VIRGINIA ELECTRIC & POWER COMPANY

SURRY POWER STATION, UNIT NO. 1

AMENDMENT TO FACILITY OPERATING LICENSE

Amendment No. 43
License No. DPR-32

FIGURE 3.F.1
ALLOWABLE OPERATING PARAMETERS
FOR HIGH SERVICE WATER TEMPERATURES
SURRY POWER STATION UNITS 1 & 2

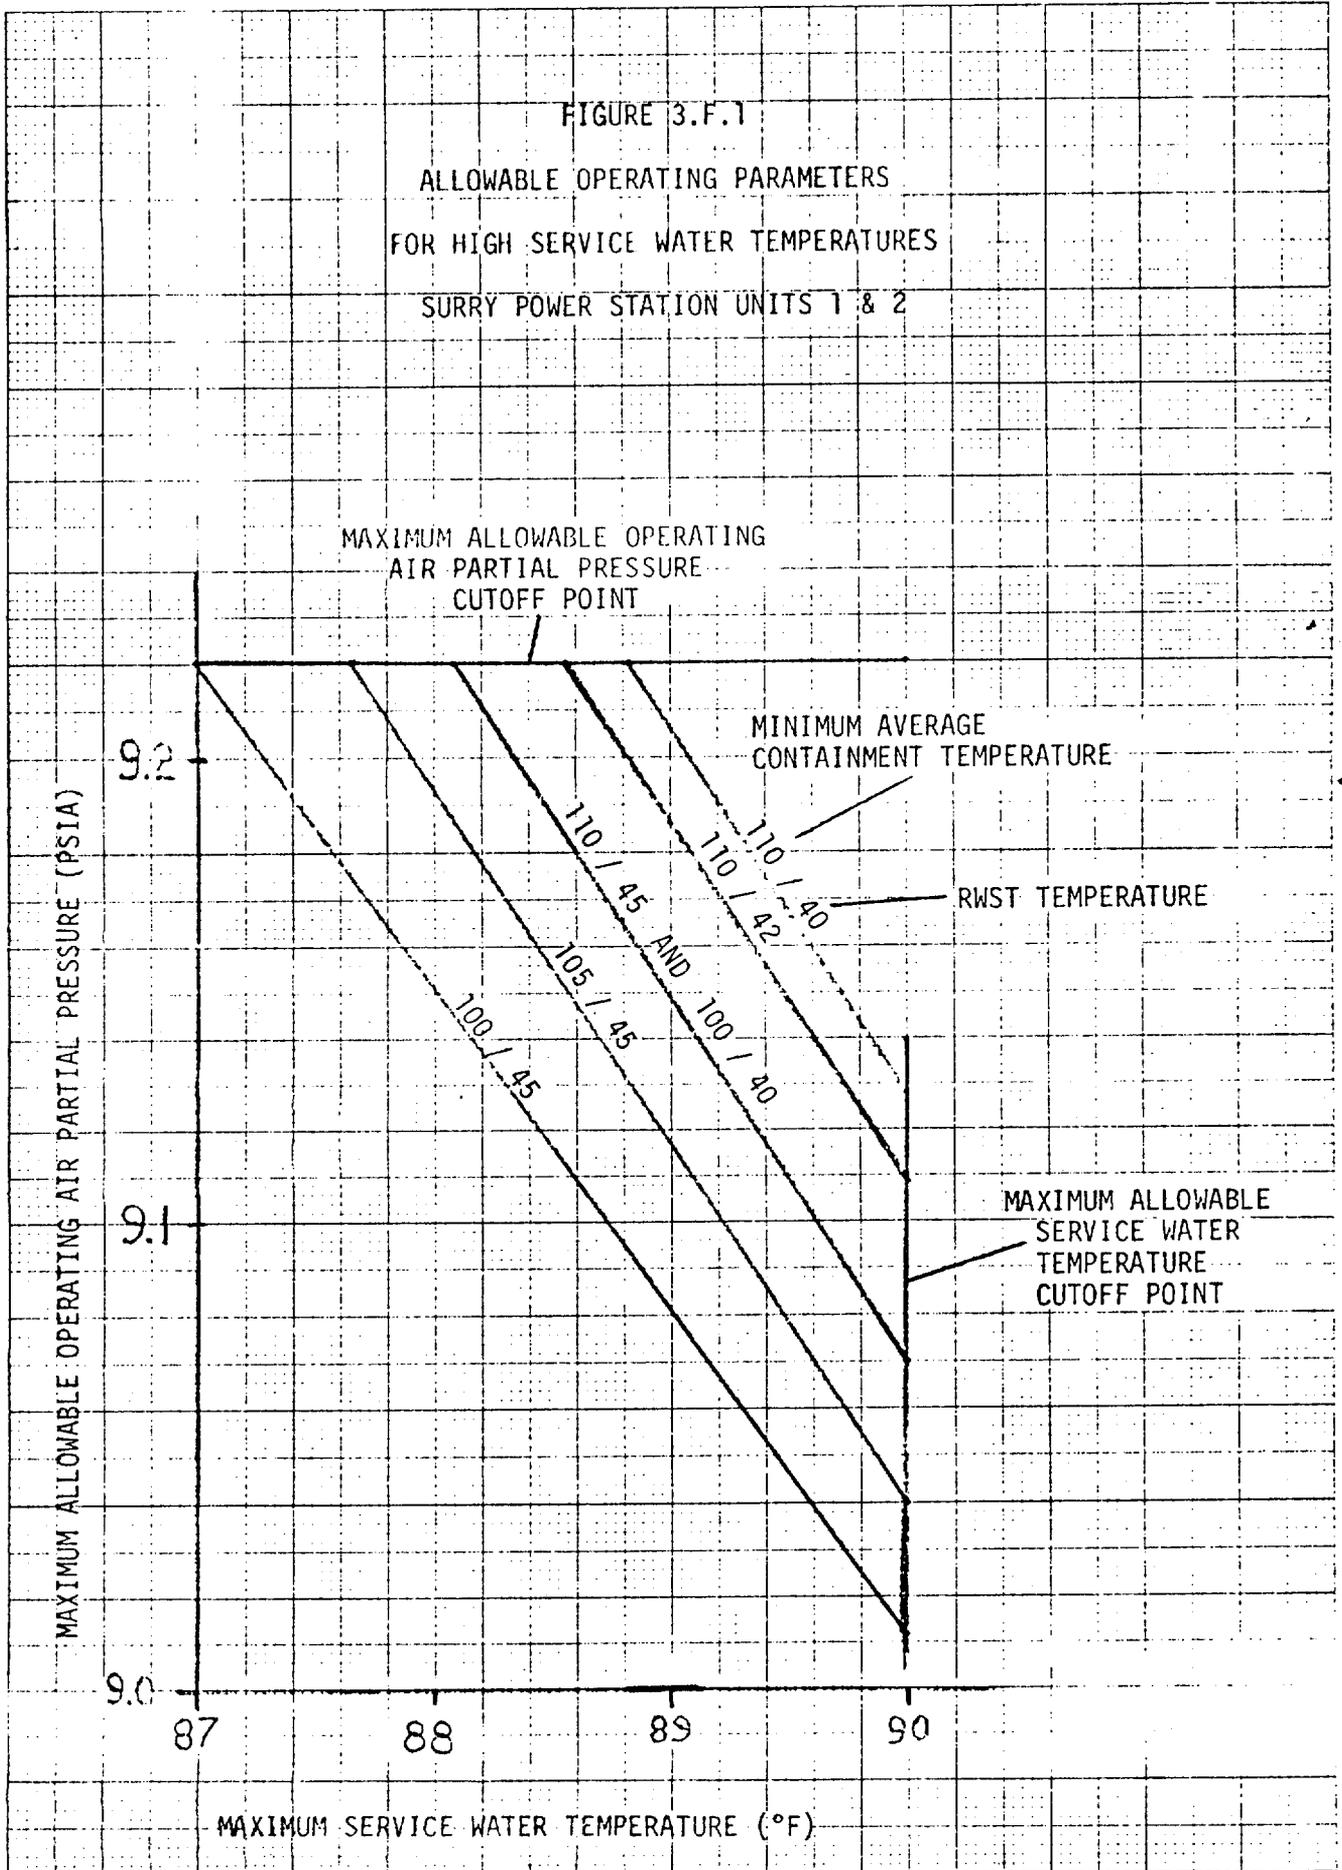
| 2. For Service Water Temperature $> 87^\circ$ | Air partial pressure shall be maintained in accordance with Figure 3.F.1. |

FIG 3.F.2

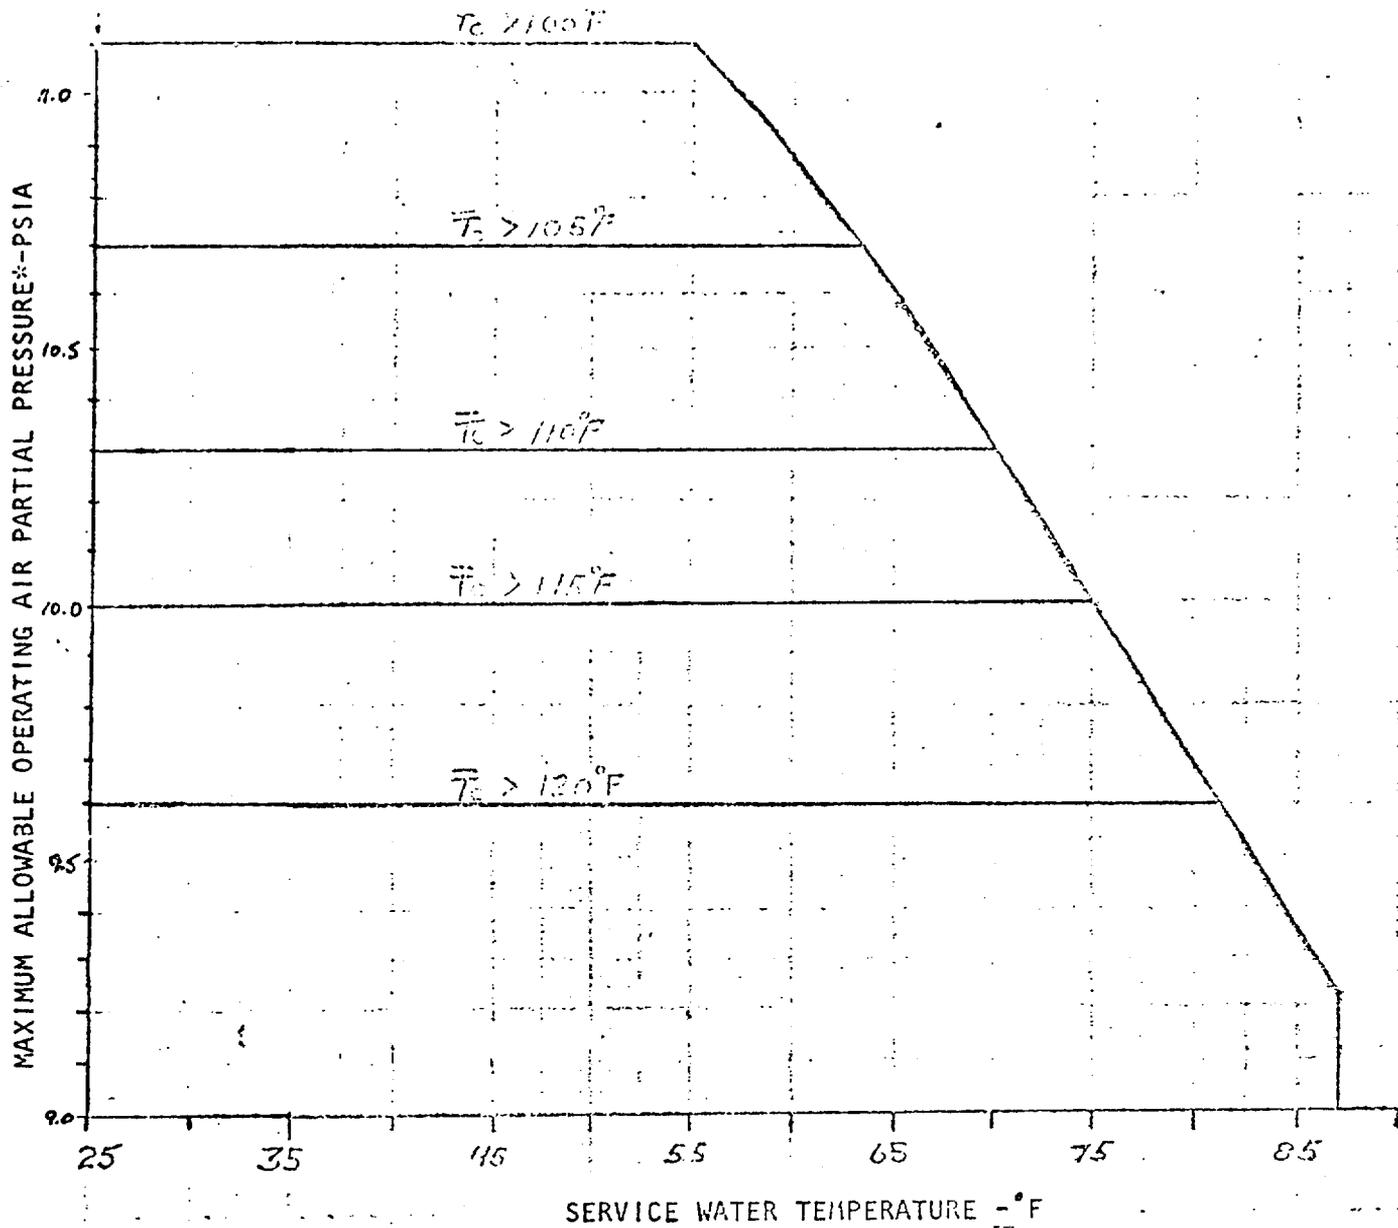
| 1. For Service Water Temperature $\leq 87^\circ$ | Air partial pressure shall be maintained in accordance with Figure 3.F.2 |

FIGURE 3.F.1
ALLOWABLE OPERATING PARAMETERS
FOR HIGH SERVICE WATER TEMPERATURES
SURRY POWER STATION UNITS 1 & 2

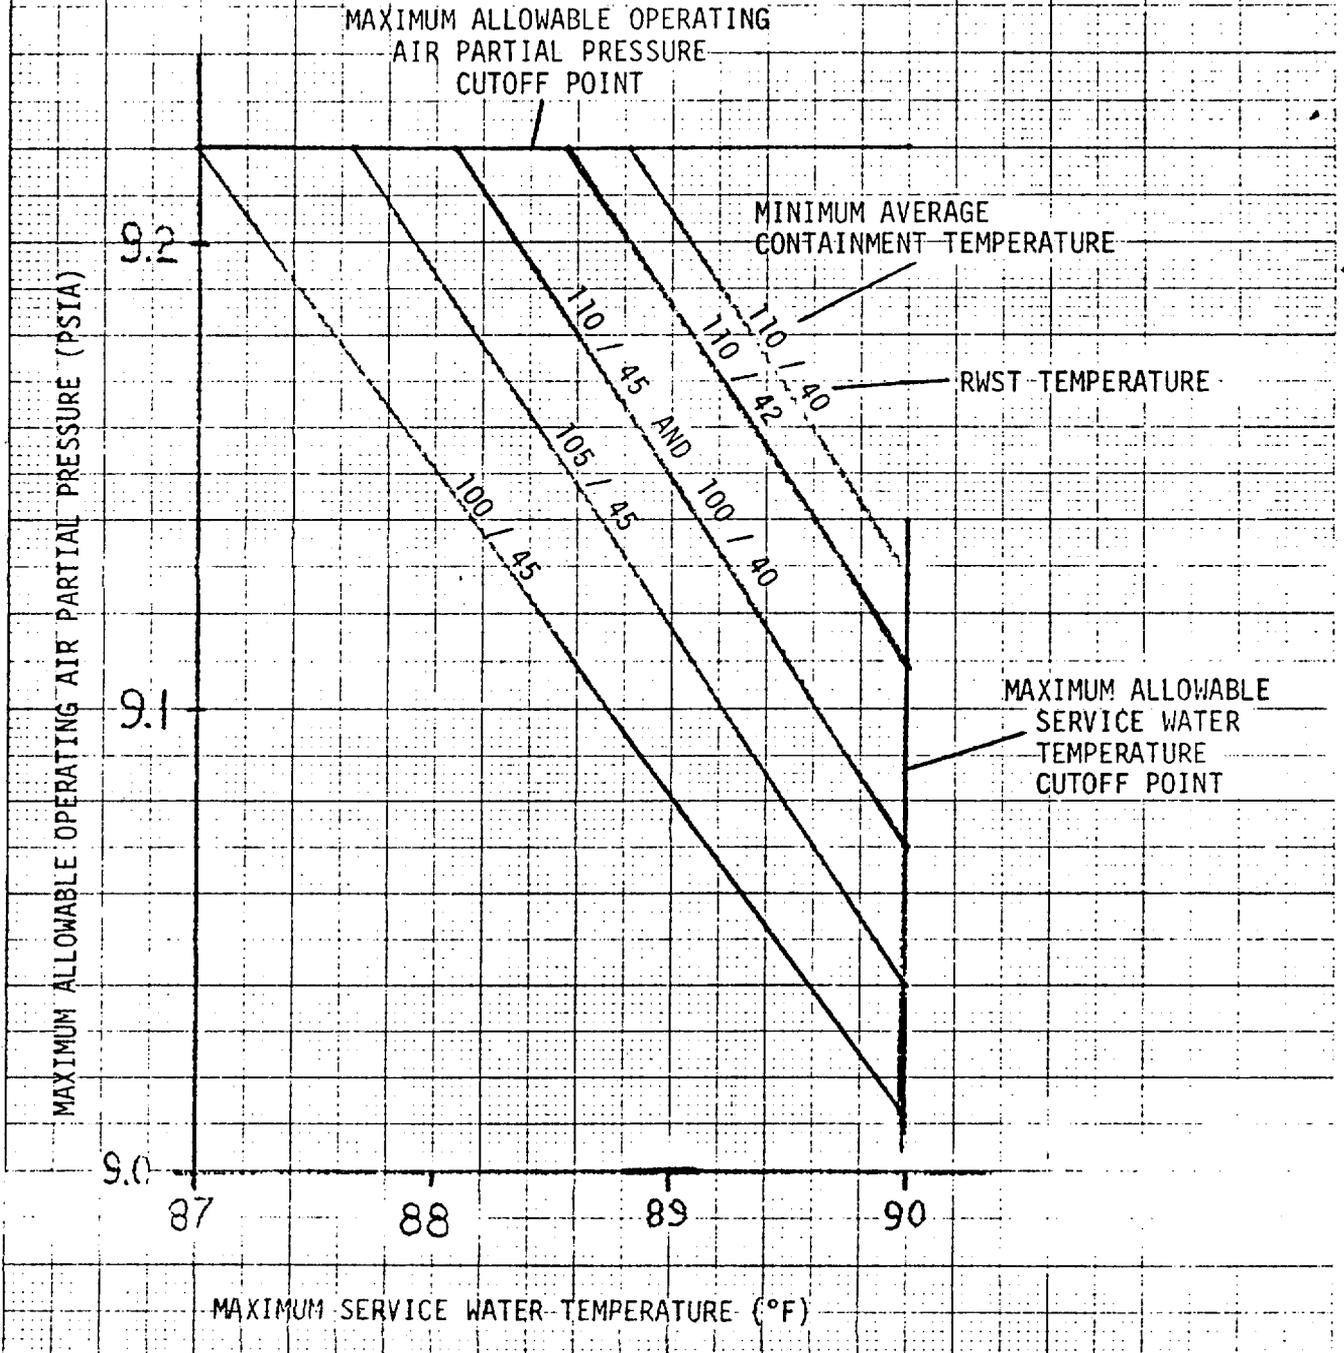
| 2. For Service Water Temperature $> 87^\circ$ | Air partial pressure shall be maintained in accordance with Figure 3.F.1. |

FIG 3.F.2

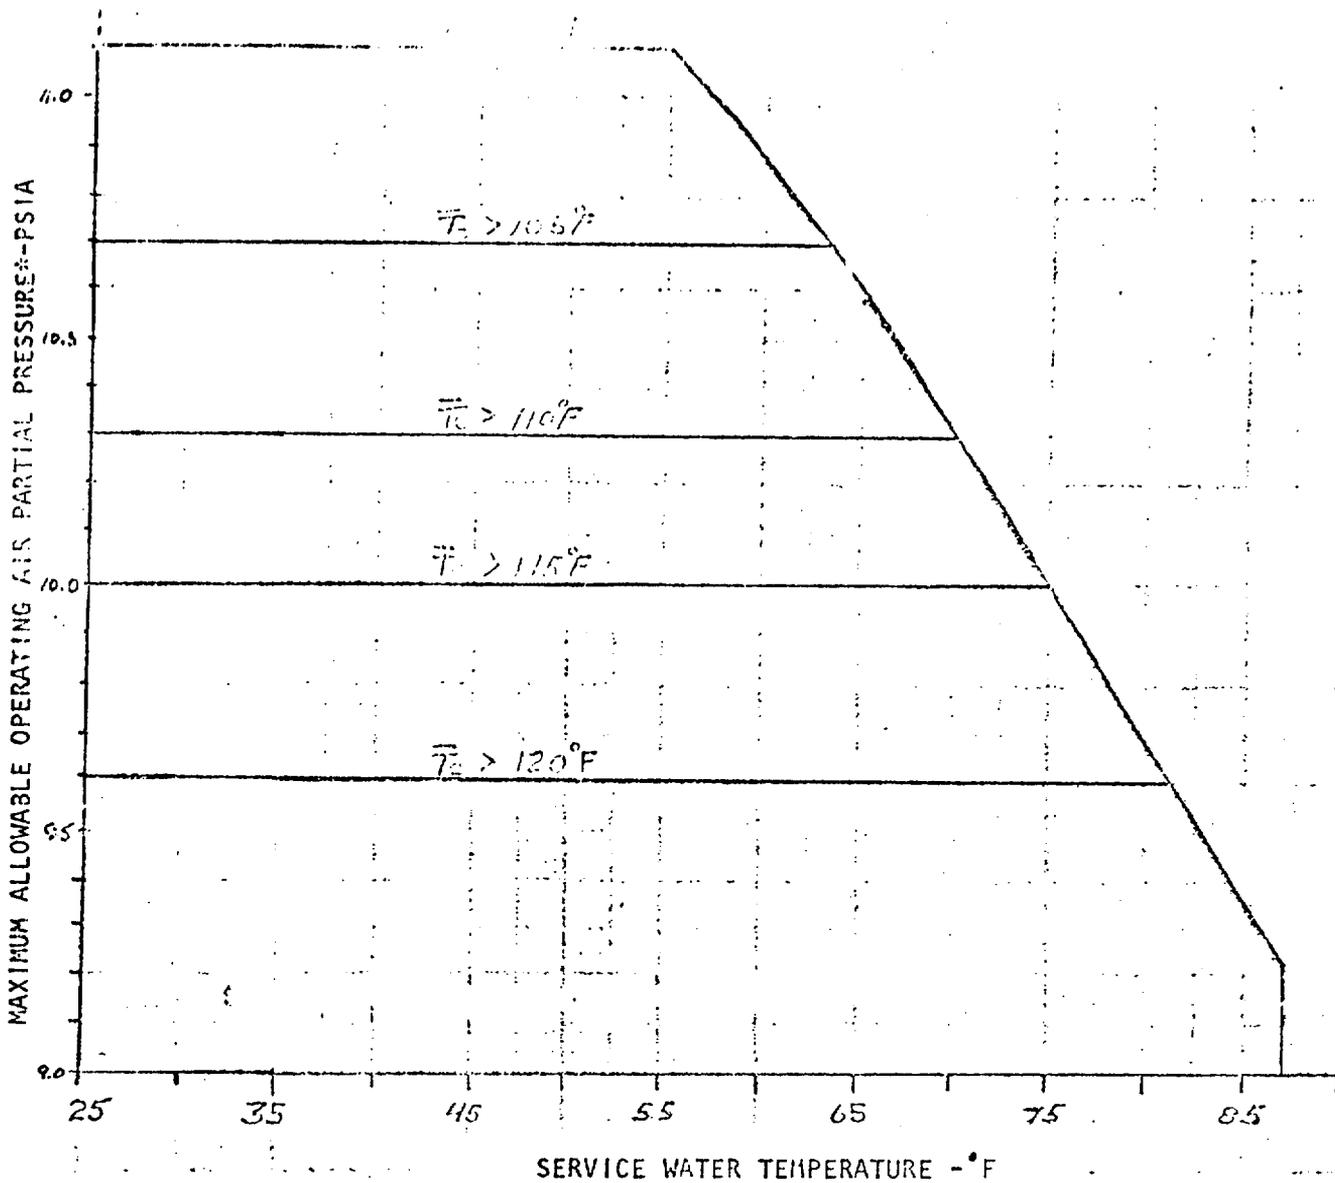
| 1. For Service Water Temperature $\leq 87^\circ$ | Air partial pressure shall be maintained in accordance with Figure 3.F.2 |
